Access Compliance Report

Public Rights-of-Way

(Curb Ramps)

Intersection ID: N/A	Main Street: CANTERBURY_CASTLE_DR	Cross Street: NICHOLS_HALL	Location: NW
ADA ID: 37329233EFC2	Ramp Type: Perp	Initial Pass/Fail: Fail	Overall Compliance: No
Codes/Mitigation Info/Possible Solution		Field Measurements/Component Compliance	
Severity Score: 8.75

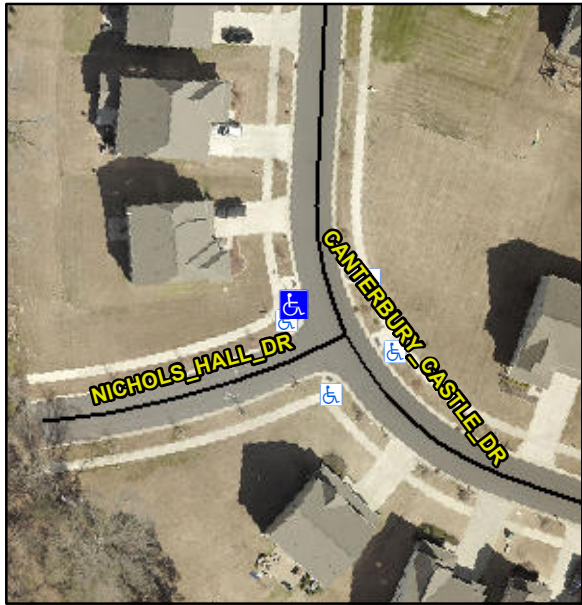
Possible Solutions:			
	Remove & Replace Entire Ramp.			
	Surveyor Notes:			
	N/A			
	PROW/ADA:			
	R304.5.1			
	Total Cost:		\$	1850.00
	Street 1 Name		CANTERBURY CASTLE DR	
	Stop Condition-Street 2		None	
	Street 2 Name		N/A	
Stop Condition-Street 1		N/A

Compliance	Description	Data	Compliance	Description	Data
N/A	Ramp Length (in)	97.0	Yes	Ramp Slope (%)	8.1
No	Ramp Width (in)	46.5	Yes	Ramp XSlope (%)	0.7
N/A	Flare Type LT	N/A	N/A	Flare Type RT	N/A
N/A	Flare Slope LT (%)	N/A	N/A	Flare Slope RT (%)	N/A
N/A	Flare Traversable LT?	N/A	N/A	Flare Traversable RT?	N/A
N/A	Landing Length (in)	N/A	N/A	DWS Provided?	N/A
N/A	Landing Width (in)	N/A	N/A	DWS Contrast?	N/A
N/A	Landing Slope (%)	N/A	N/A	DWS Length (in)	N/A
N/A	Landing X Slope (%)	N/A	N/A	DWS Full Width?	N/A
N/A	Landing Curb? (Y/N)	N/A	N/A	DWS Offset (in)	N/A
N/A	Shared Landing?	N/A			
N/A	Gutter Ponding?	N/A	N/A	Gutter Slope (%)	N/A
N/A	Gutter Lip Ht (in)	N/A	N/A	Gutter X Slope (%)	N/A
N/A	Painted X Walk1?	No	N/A	Painted X Walk2?	N/A
	X Walk 1 Direction	To E		X Walk 2 Direction	N/A
N/A	X Walk 1 Width (in)	N/A	N/A	X Walk 2 Width (in)	N/A
	X Walk 1 Slope (%)	3.4		X Walk 2 Slope (%)	N/A
	X Walk 1 X Slope (%)	3.7		X Walk 2 X Slope (%)	N/A
